REGULAR MEETING OF THIRD LAGUNA HILLS MUTUAL ARCHITECTURAL CONTROLS AND STANDARDS COMMITTEE*

**Thursday, August 14, 2023 – 1:30 p.m.
Laguna Woods Village Board Room/Virtual Meeting
24351 El Toro Road, Laguna Woods, California**

NOTICE AND AGENDA

VIEW FROM OVALO ALONG GARAGE SIDE
OF 5079 OVALO

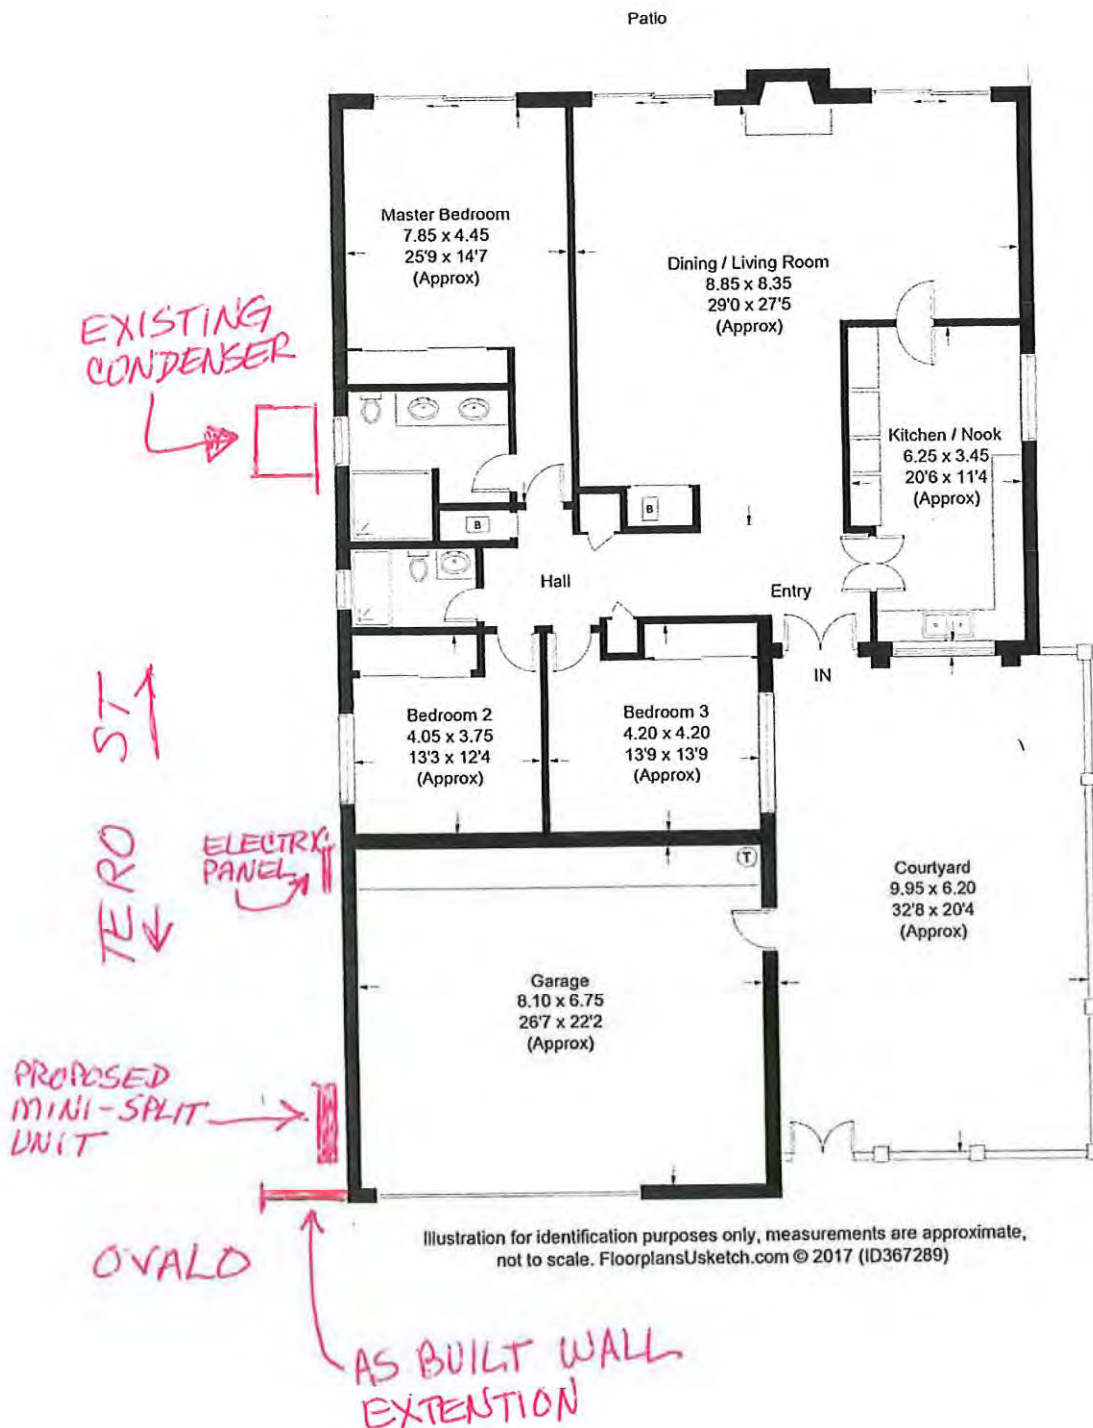
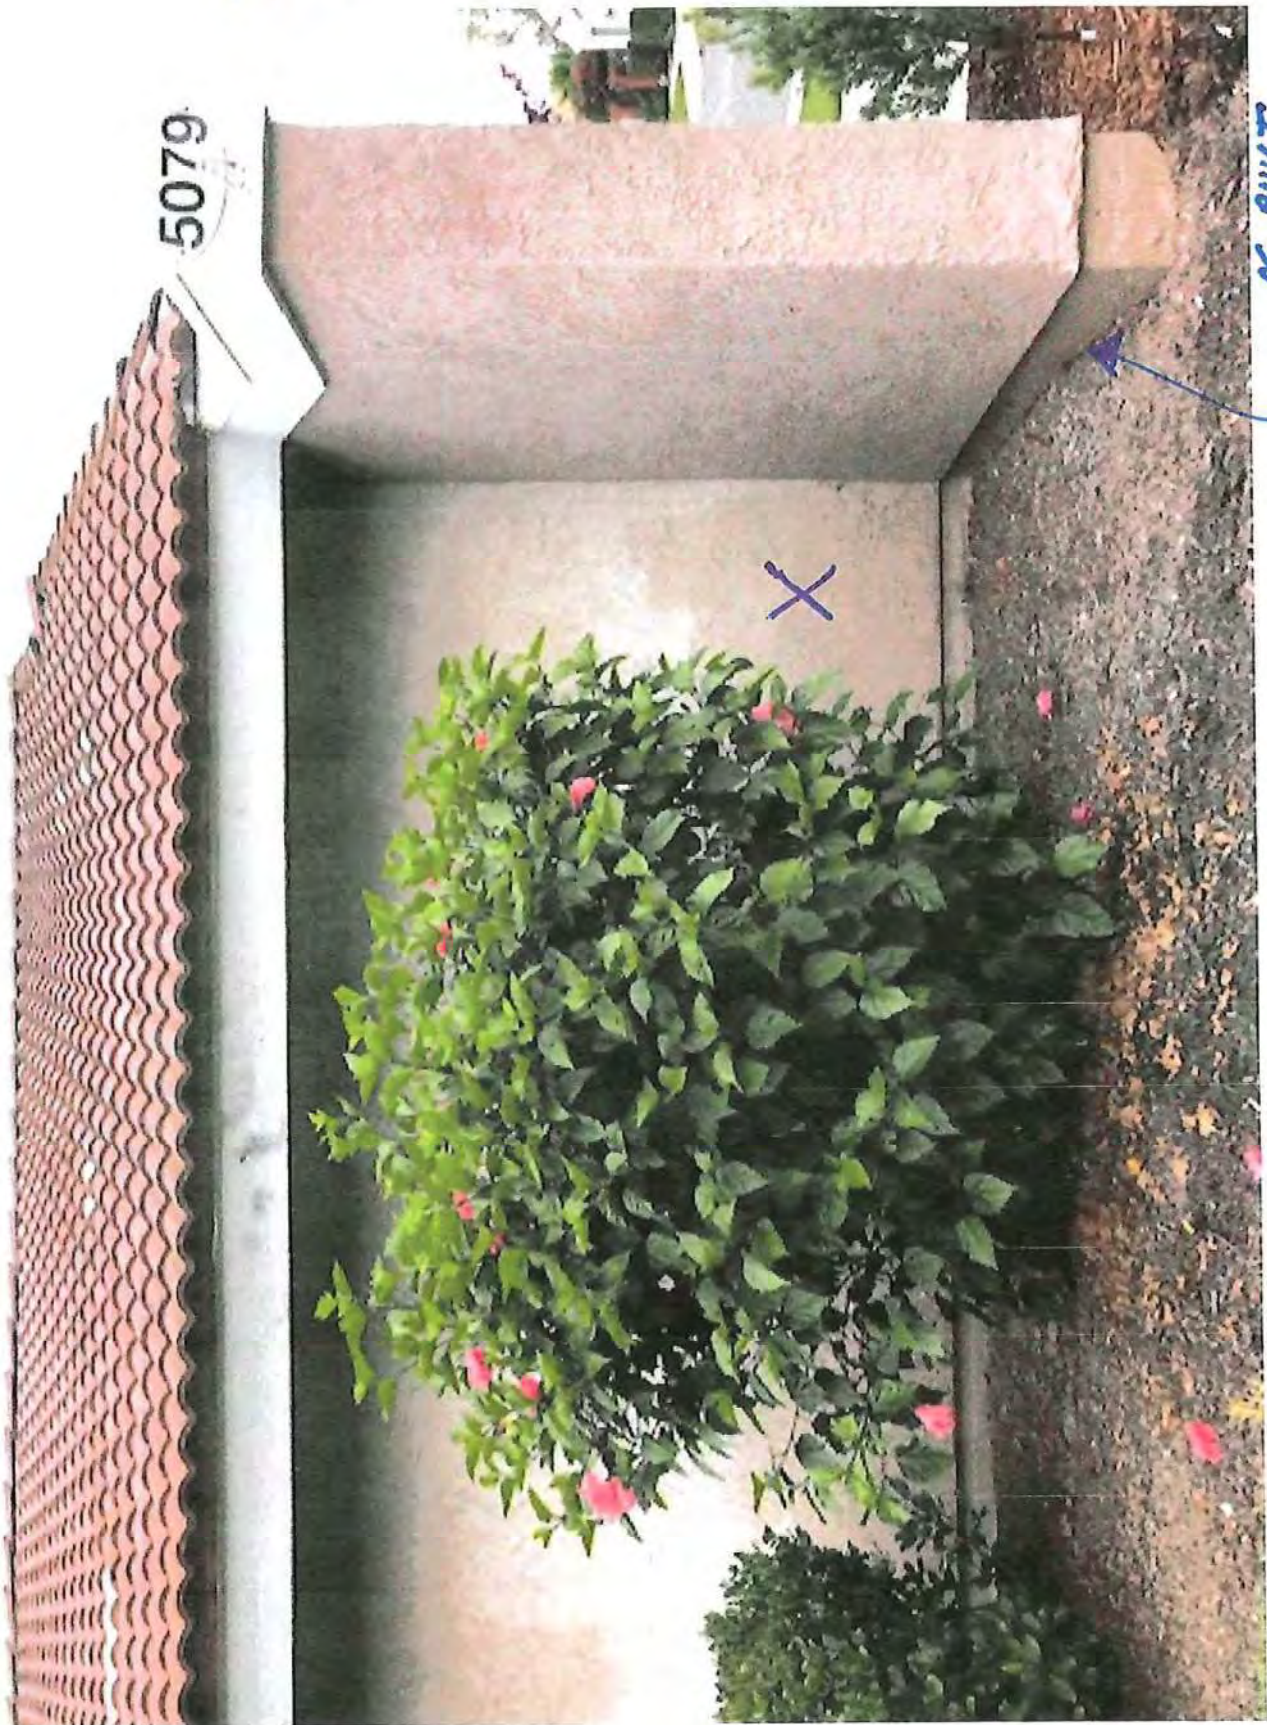
Description of Proposed Variance Request ONLY: PREFER EMAILING DOCUMENT REQUEST CONSENT TO ADD A SECOND CONDENSER TO PROVIDE CLIMATE CONTROL EQUIPMENT FOR THE GARAGE. THE EXISTING CONDENSER CANNOT BE USED DUE TO FIRE WALL.

5. Since my house is on the corner of Ovalo and Tero, my next-door neighbor is on the other side of Tero. Because of the decorative wall at the side of my garage, the unit will not be visible from the houses across the street on Ovalo. Due to the substantial Bottle Brush hedge along Tero, the unit will not be visible to anyone walking along Tero.
6. The proposed site is near the electrical box (circuit breakers) should any modification be required as may be recommended by the City of Laguna Woods.
7. The mini-split unit is substantially below the 71 db rating requirement of Standard 4

- A.1. This approval does not change the number of bedrooms or the original maximum occupants permitted in the Unit.
- A.2. No future modifications can be made to the garage to create a “habitable space” as defined by International Resident Code (IRC).
- A.3. The Member shall provide plans and specifications to conform to the Building Code for the work of this variance.

REMODELED
 FLOOR PLAN
 ELECTRICAL PLAN

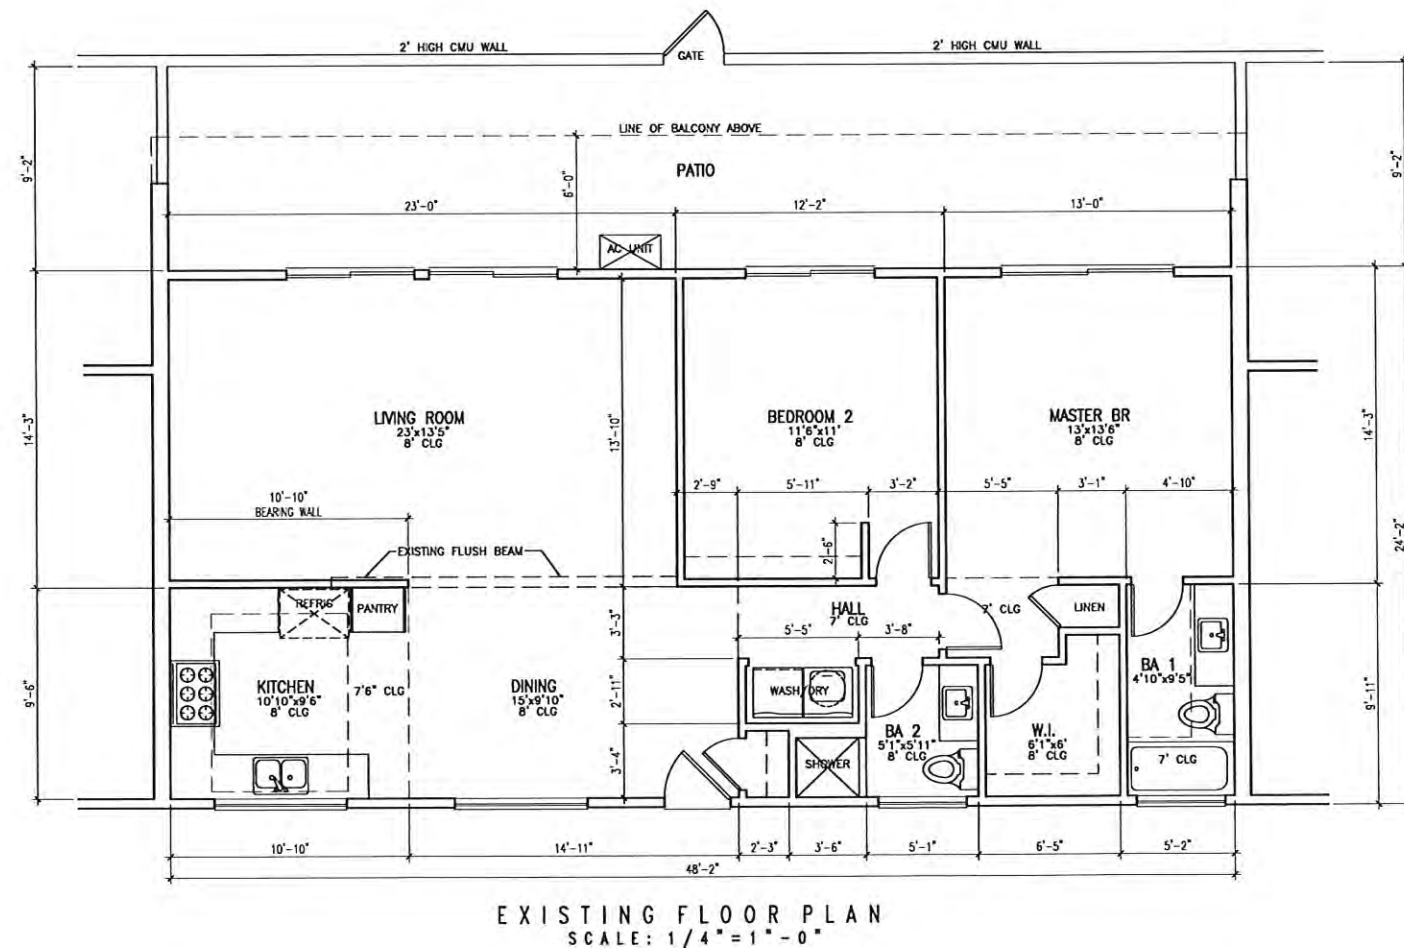
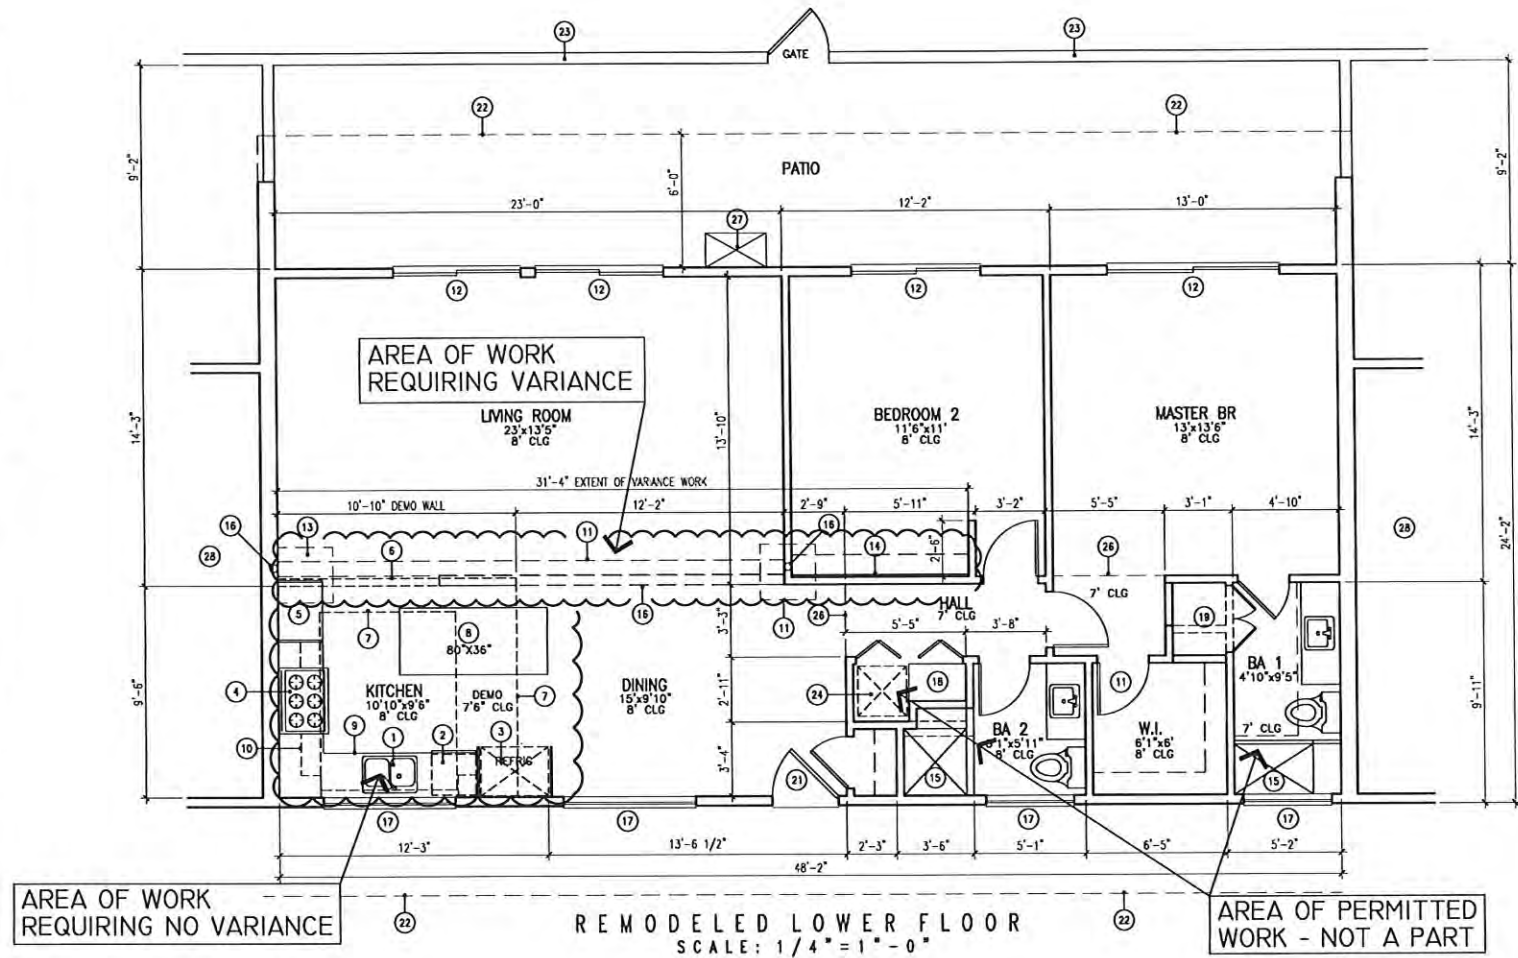
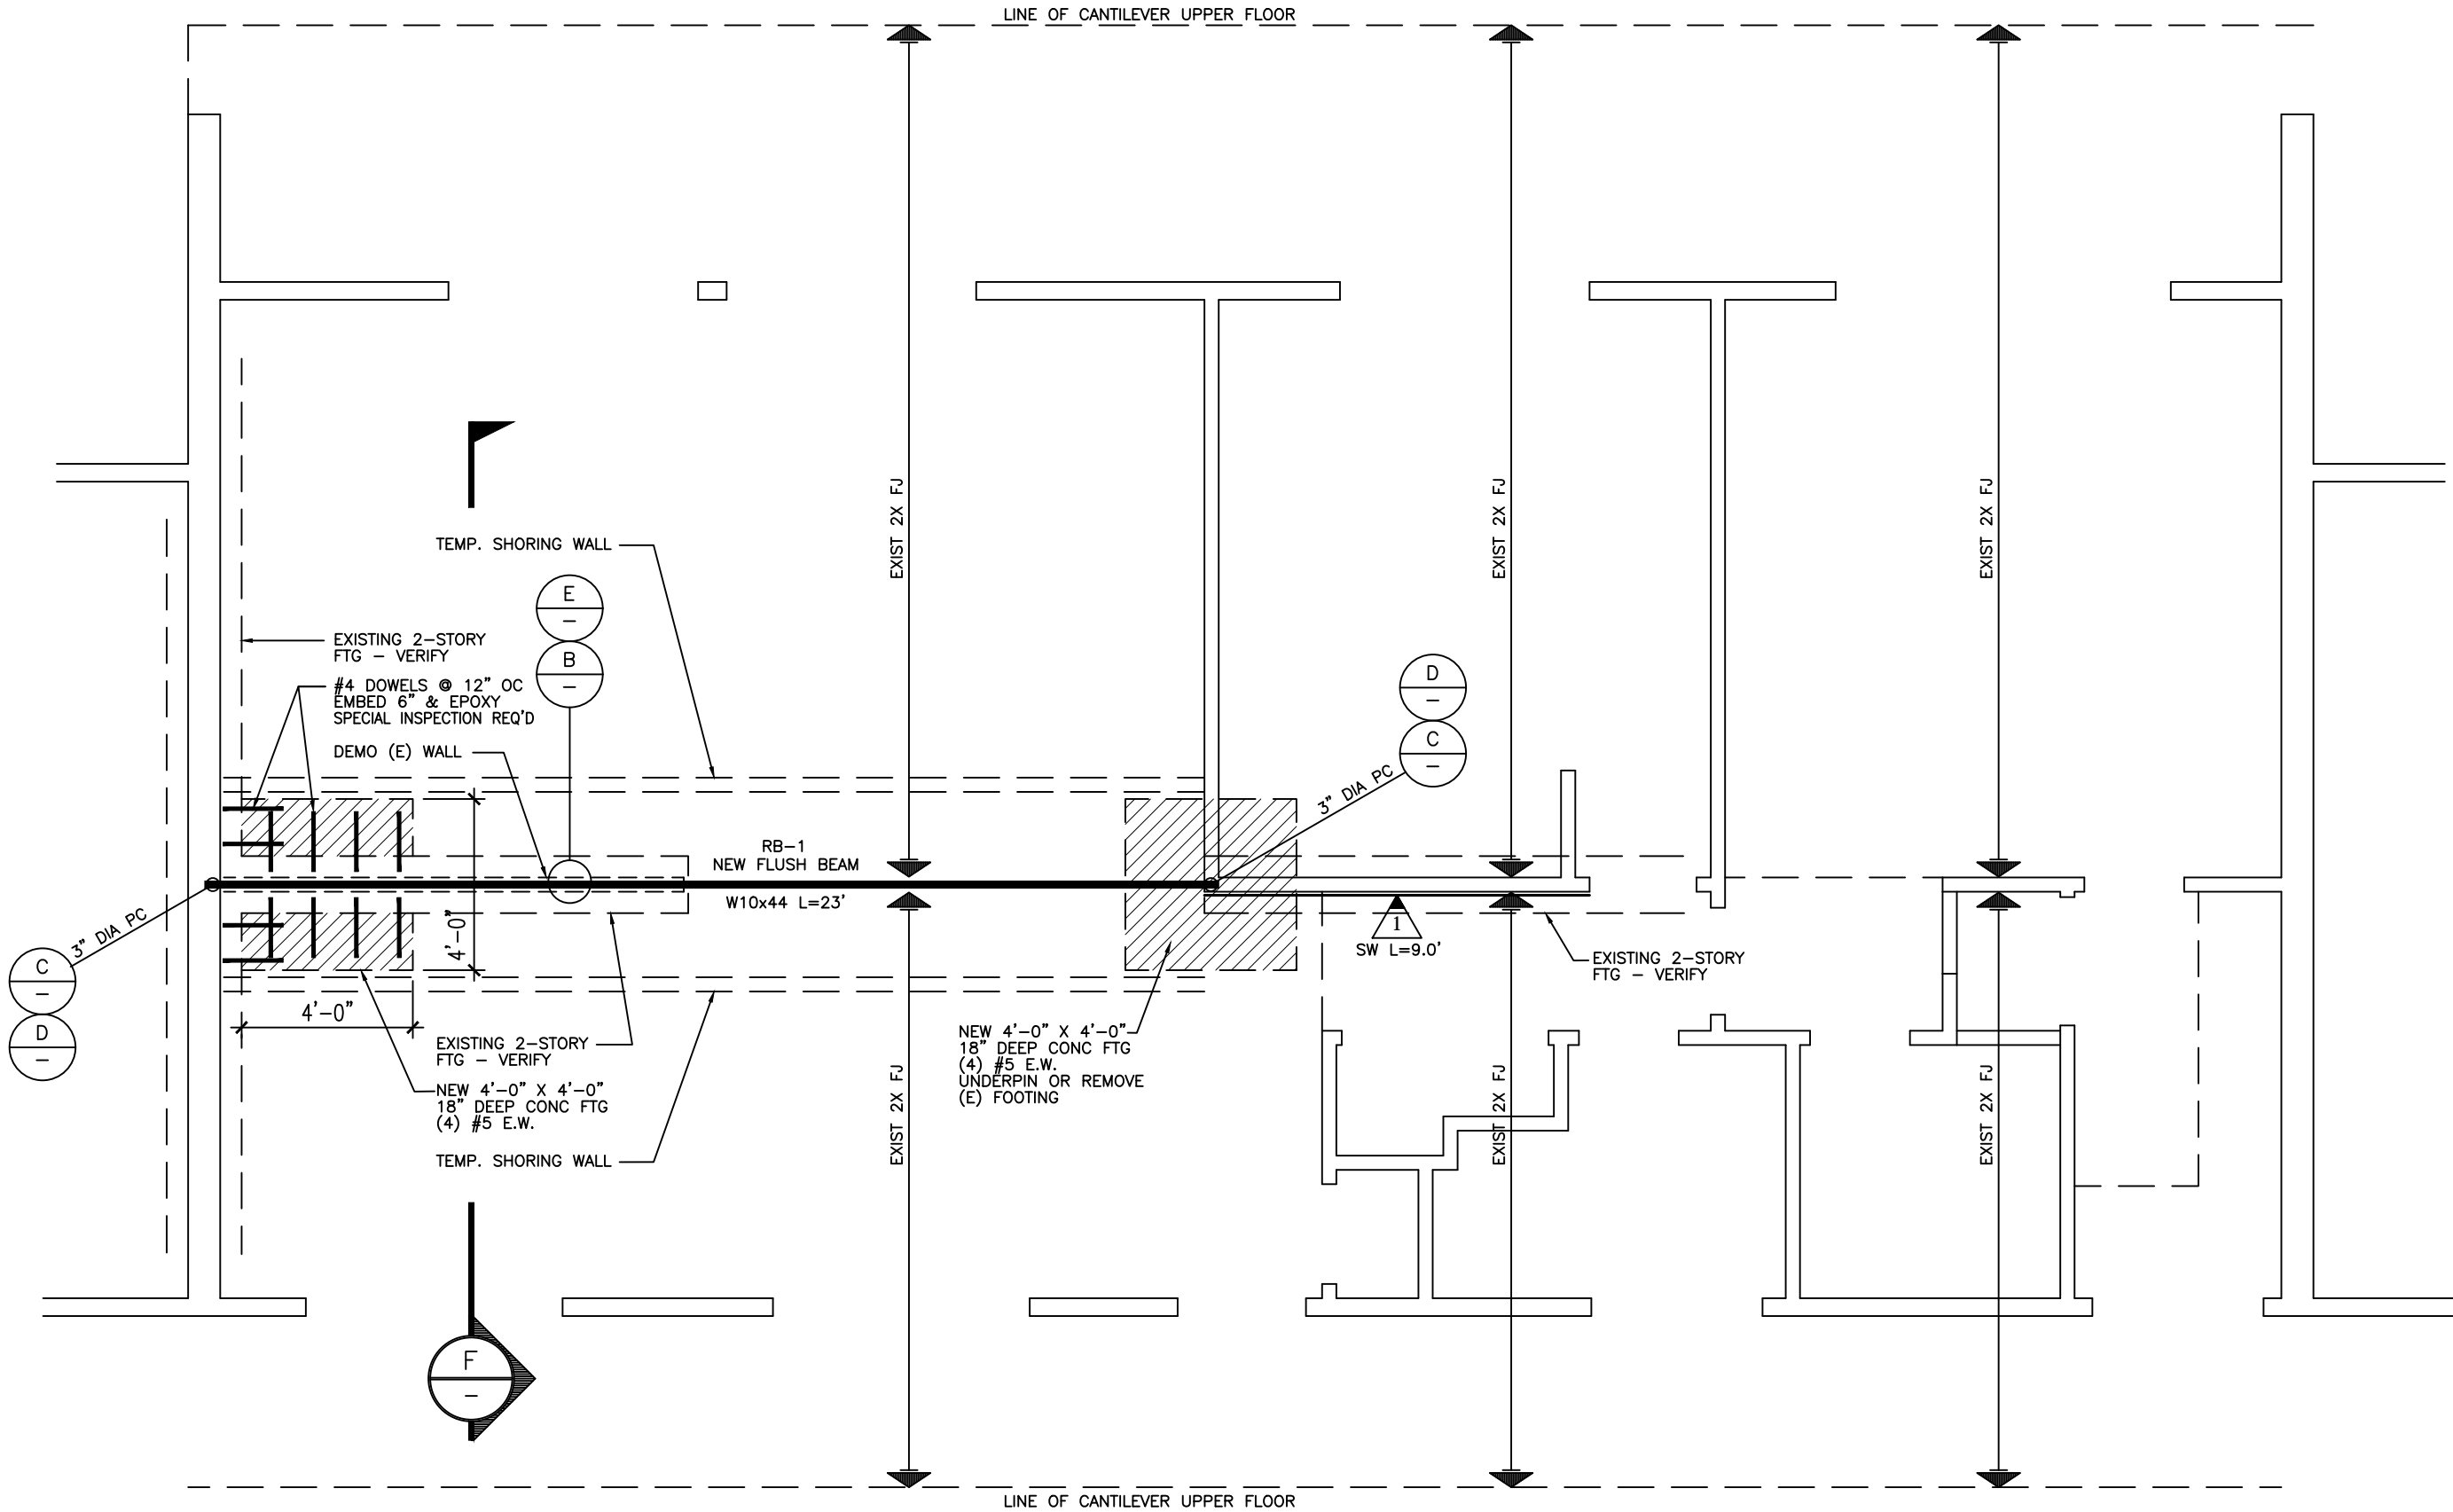
REMODEL KITCHEN
 REPLACE ALL KITCHEN CABINETS AND LIGHTING
 DEMOLISH STRUCTURAL WALL BETWEEN KITCHEN AND LIVING ROOM*
 ADD FLUSH STEEL BEAM ABOVE DEMOLISHED WALL*
 EXISTING FLUSH WOOD BEAM TO REMAIN IN PLACE
 ADD CONCRETE FOOTINGS AND COLUMNS BELOW ENDS OF NEW BEAM*
 ADD PLYWOOD SHEAR PANEL TO EXISTING WALL AT BEDROOM 2*

- A.1. This approval does not change the number of bedrooms or the original maximum occupants permitted in the Unit.
- A.2. The Member shall provide plans, specifications, and calculations from a duly licensed architect or structural engineer to conform to the Building Code for all foundation, framing, and beam additions for the work of this variance.
- A.3. A City of Laguna Woods Building Permit will be required and provided to Manor Alterations to verify all code requirements for new or modified structural components, and shoring have been satisfied.
